REMARKS

Serial No.: 09/686,031
Conf. No.: 5932

Annotated Sheet Showing Changes

Fig 4

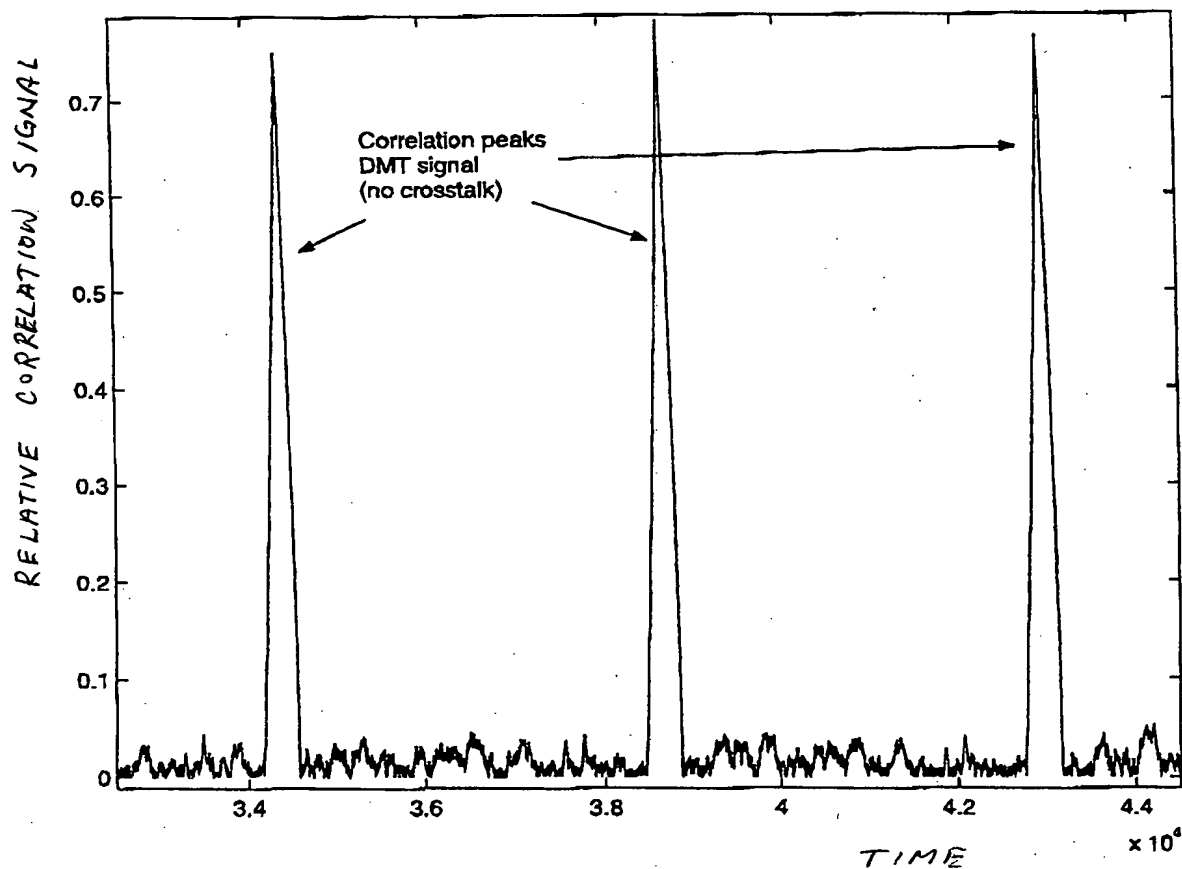
The Examiner has objected to the drawings and has suggested that units of the x and y axes be added to Figs. 4 and 5. Enclosed herewith are photocopies of Figs. 4 and 5 with proposed changes marked in red. Approval of the proposed drawing corrections is respectfully requested.
